VIII. Fuse Plug Design, Construction and Activation

A. Fuse Plug Design.

The MWH Design Report dated March 2002 provided design data for the Silver Lake fuse plug. Items of design data were extracted from the Design Report for presentation and discussion in this Section. Applicable comments and findings are incorporated with the design items

The design plan of the fuse plug, its spillway channel, and profile are shown in MWH drawing 20895-C5. The design cross section of the fuse plug and rock trench section are in MWH drawing 20895-C6.

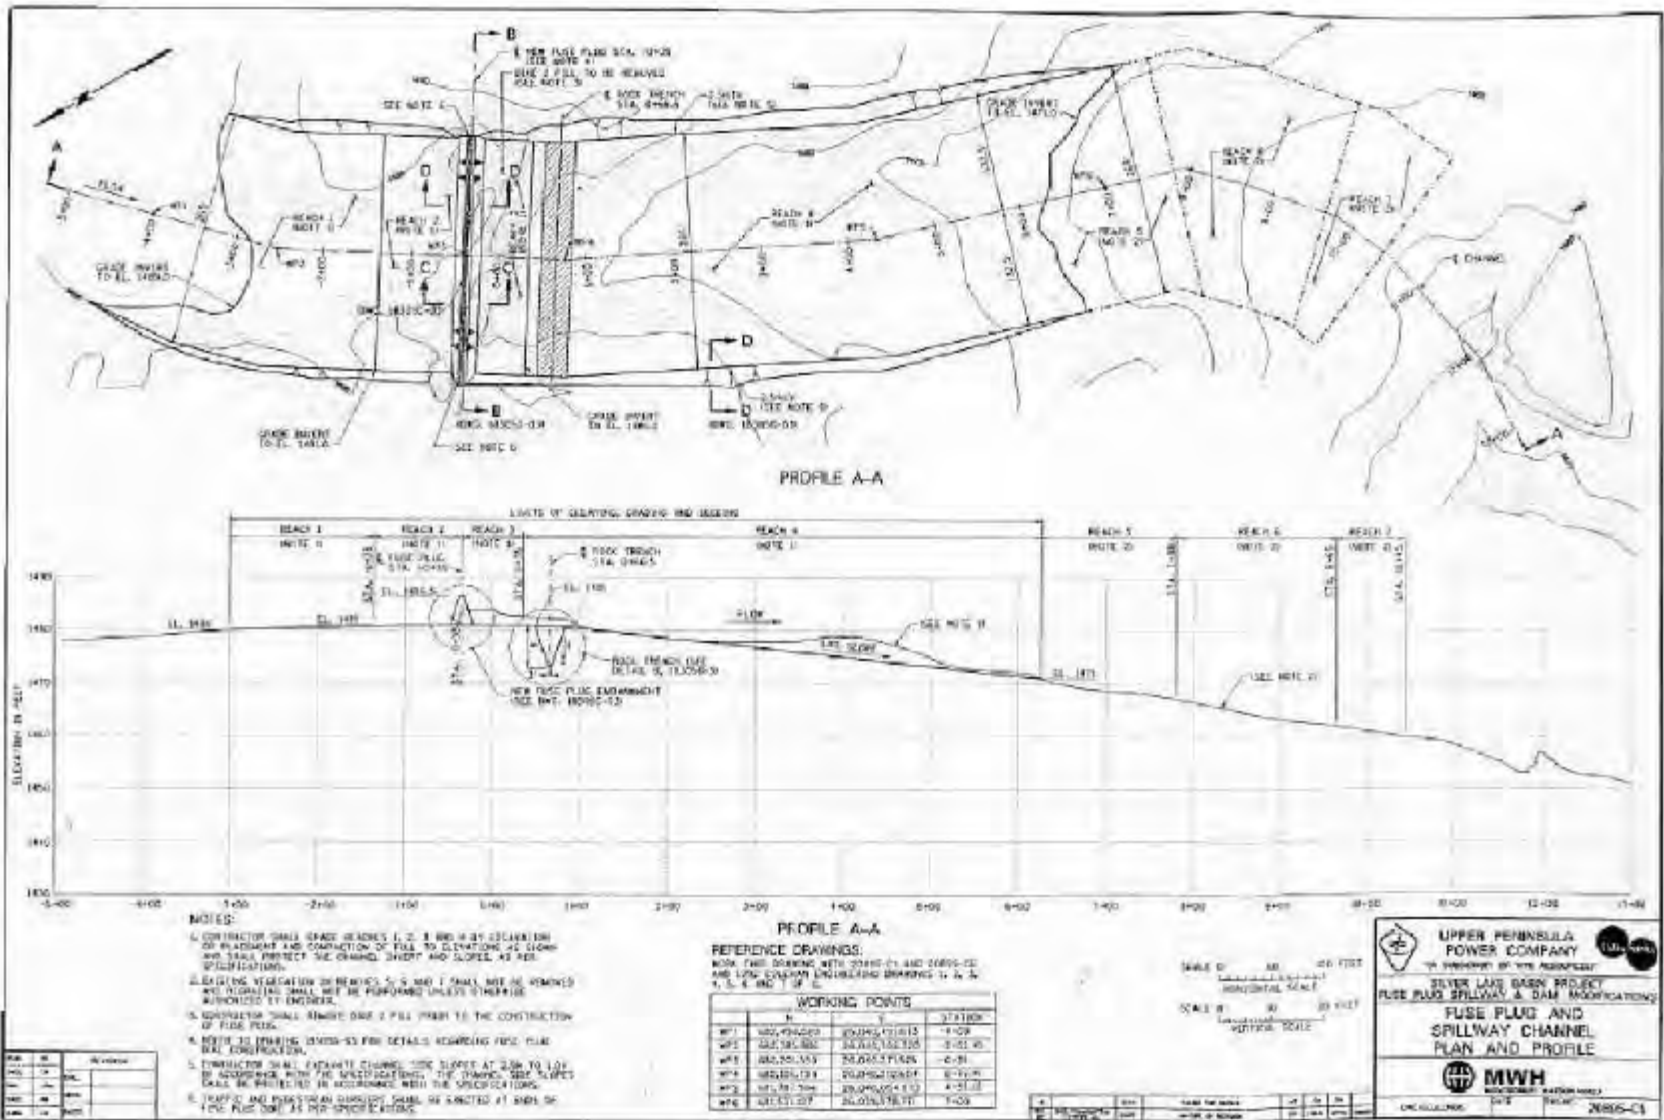
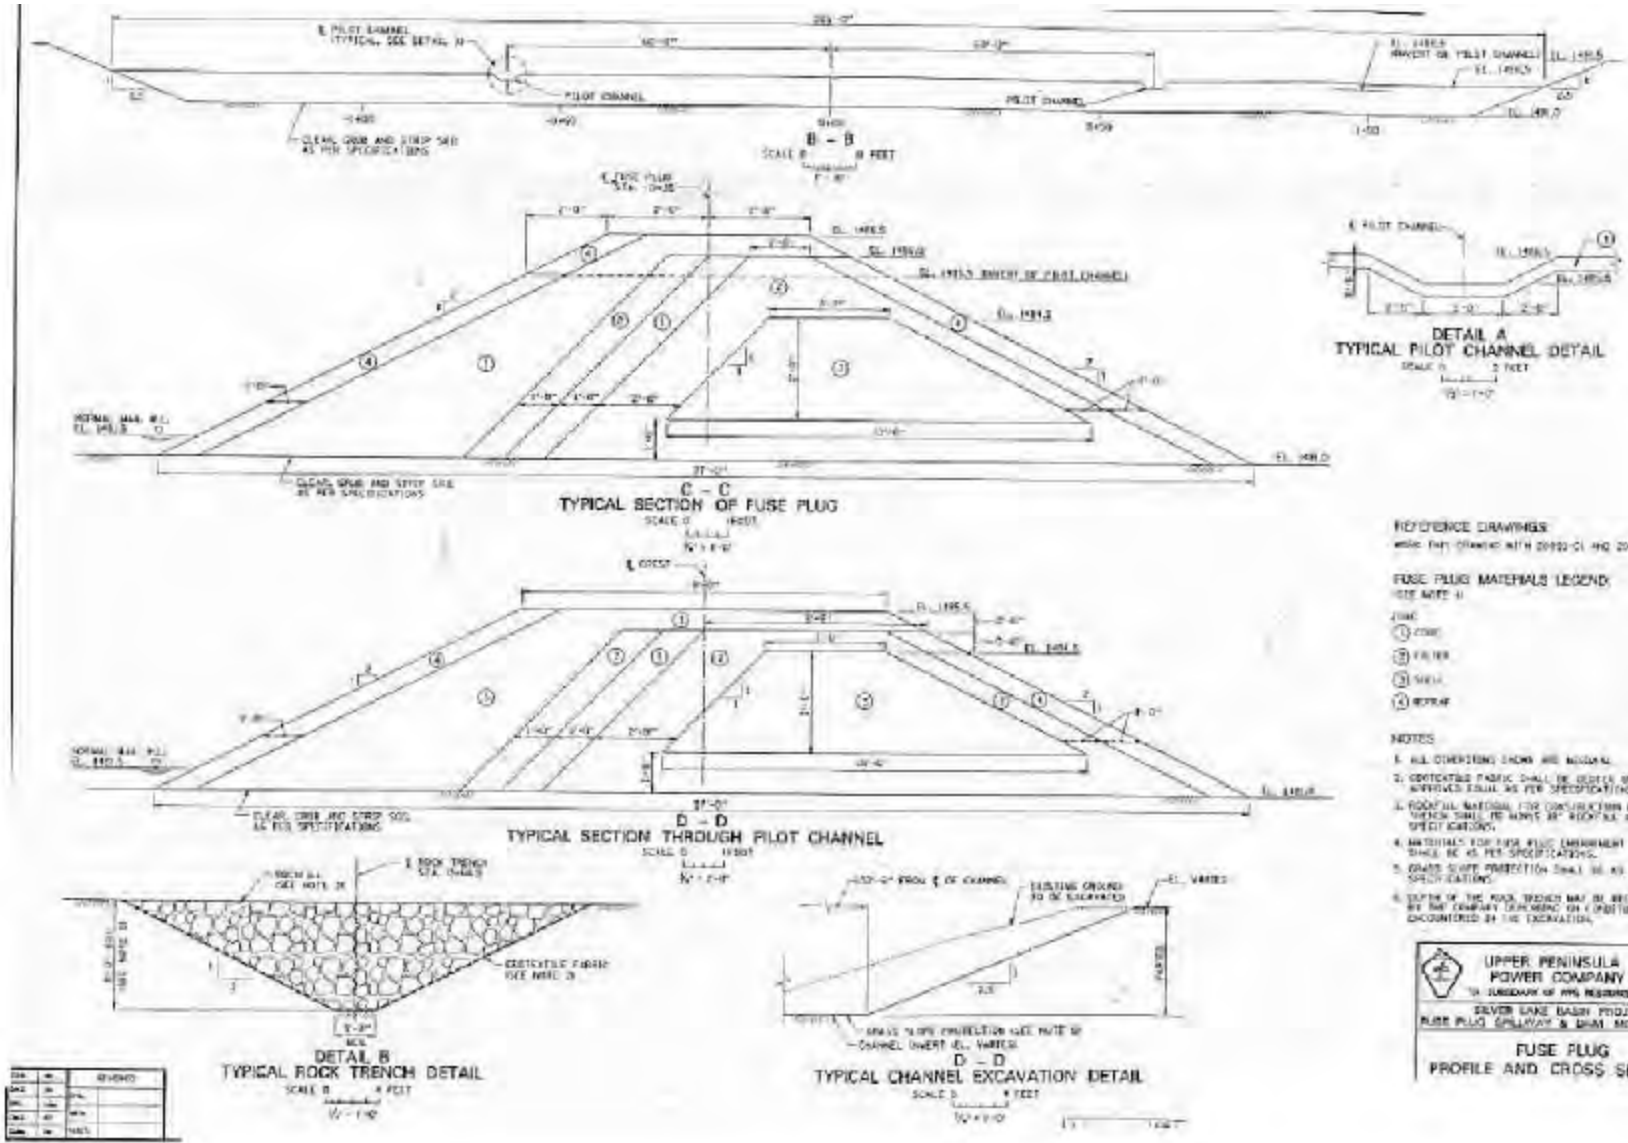
As noted on the design and as-built fuse plug cross section and pilot channel cross section drawings, the top of the design fuse plug is elevation 1486.5 feet and the pilot channel elevation is 1485.5 feet respectively. As-constructed survey of the fuse plug dike indicates the two pilot channels to have invert elevations of 1,485.37 and 1,485.28 feet, approximately 1.5 to 2.6 inches below the design elevation of 1,485.5 feet. When these fuse plug elevations are compared to the elevation of the concrete ogee spillway crest elevation of 1486.25 feet, it becomes obvious that the concrete ogee spillway will no longer be the primary spillway. The fact the fuse plug will erode before the reservoir reaches the concrete ogee spillway crest elevation of 1486.25 feet was not discussed in the Design Report or pointed out in any other documentation that we have found. The design and as-built fuse plug cross sections and pilot channel cross sections indicate that the normal maximum water level will be 1481.5 feet. This elevation is also stated in Section 5.3 Reservoir Level, "The initial water level prior to the PMF event is at the normal maximum operating reservoir level of El. 1481.5 feet." The consultant apparently did not revised the plans and design documents to show that the normal maximum operating level was changed to El. 1482.5 feet per his letter dated September 24, 2001, which was enclosed with the licensee's September 27, 2001 letter to FERC.

When the designer representative was asked why the fuse plug was designed with a pilot channel elevation that is 0.75 feet lower than the concrete ogee spillway crest, he stated that it was not intended for the concrete ogee spillway to operate as the primary spillway after the fuse plug was installed. The designer representative stated that the primary capacity to pass lower floods would be handled by the outlet works, the slot in the fourth bay of the concrete ogee spillway (with stop logs at 1482.5 feet), and the storage volume from the lower reservoir operating level of 1481.5 feet. The outlet works and slot in the fourth bay of the concrete ogee spillway could be expected to pass approximately 634 cfs before the fuse plug would activate. The designer representative indicated that it should take greater than a 1 in 500 years event to activate the fuse plug with this design.

Initially a rock trench was planned for as indicated in Section 6.6 Rock Trench to provide additional erosion resistance to head cutting at the upper end of the 1.8% slope downstream of the fuse plug location..

As shown in the as built drawings, the rock trench was not constructed as was initially planned. UPPCO, with the concurrence of MWH twice requested to FERC to remove the trench stating that it was not considered necessary due to the relatively flat slope into the reservoir, which was observed after reservoir draw down for construction of the fuse plug. The request was initially denied per FERC letter dated September 27, 2003, but was later granted per FERC letter dated November 5, 2002.

Final Construction Report drawing MWH 20895-C5

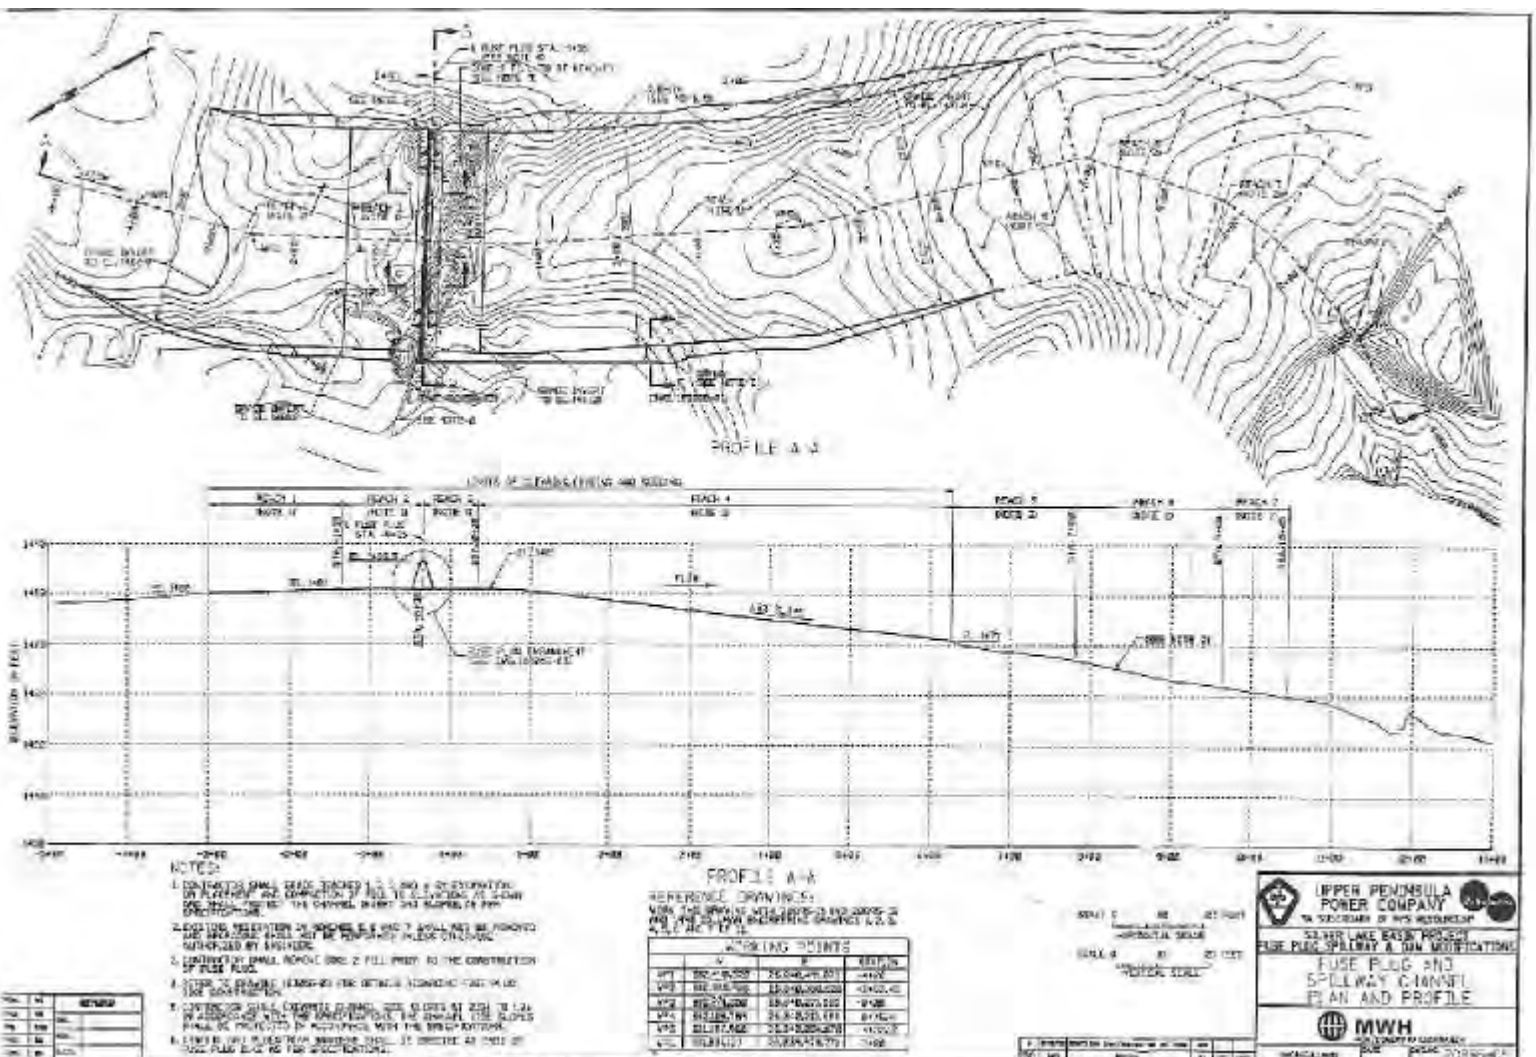
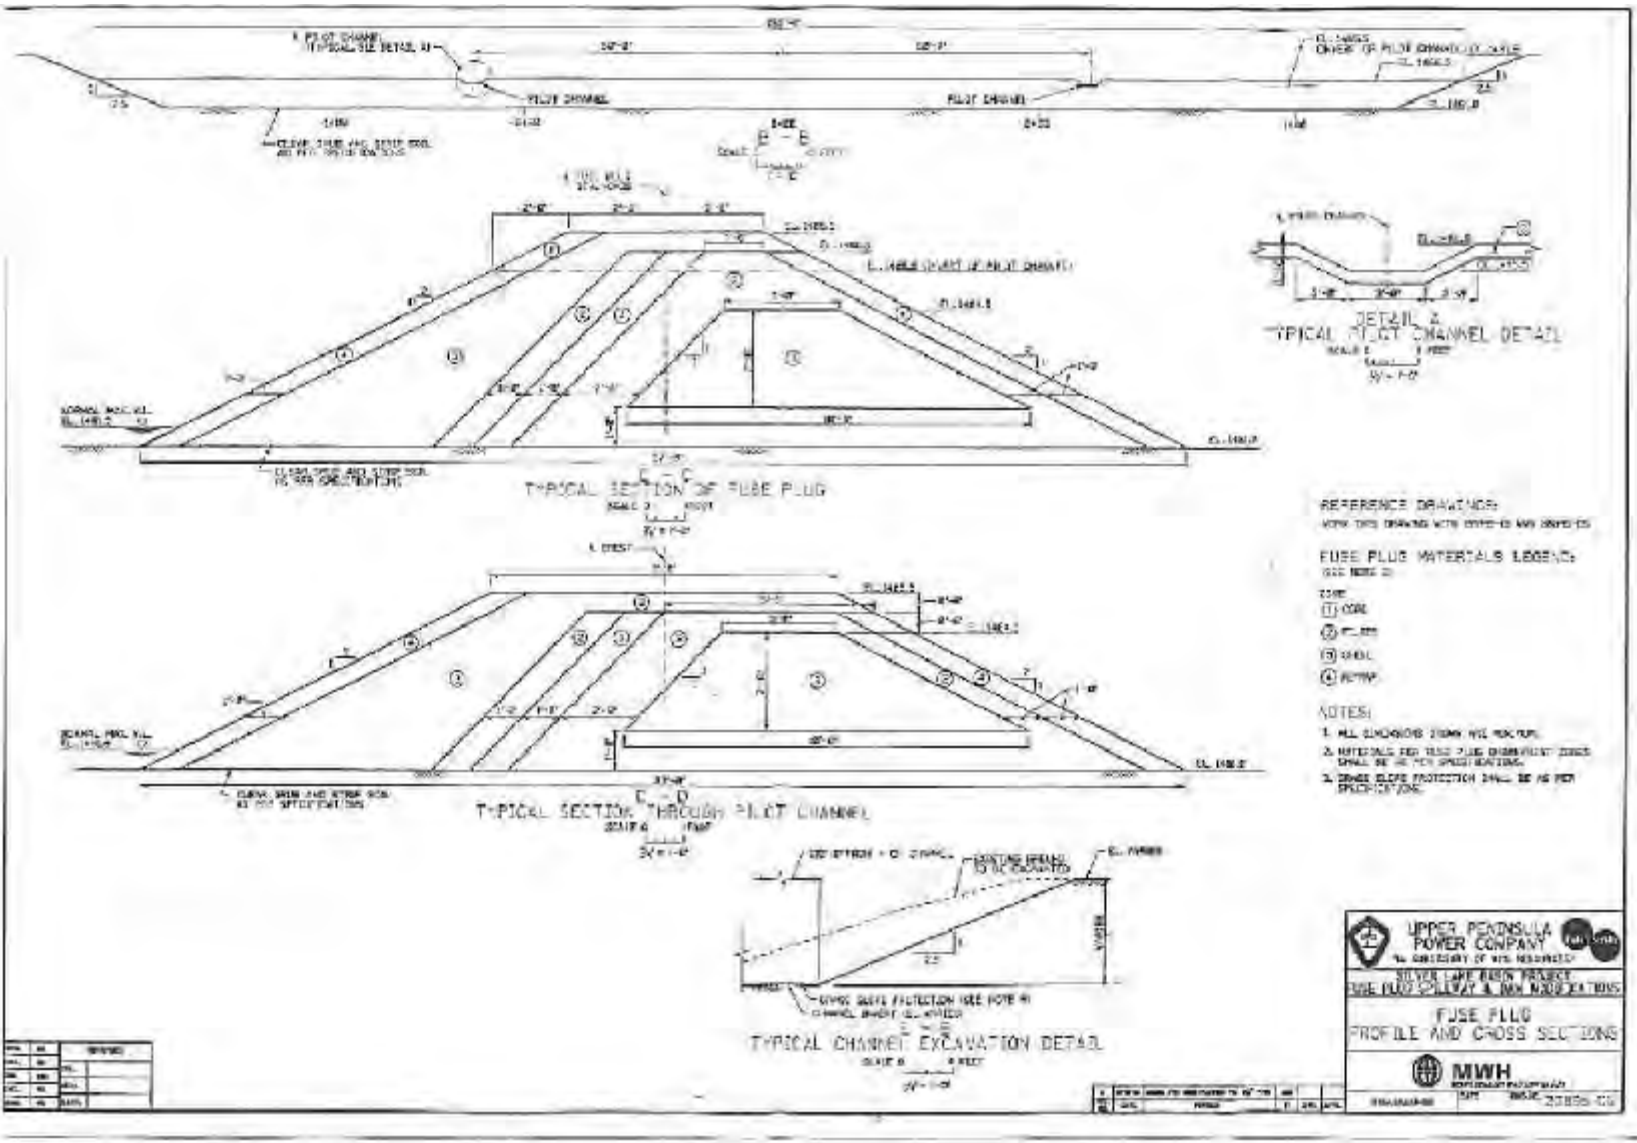
Revised MWH drawings 20895-C5 and 20895-C6 reflect the as-built construction of the fuse plug including removal of the rock trench, which was requested several times from MWH before being accepted.
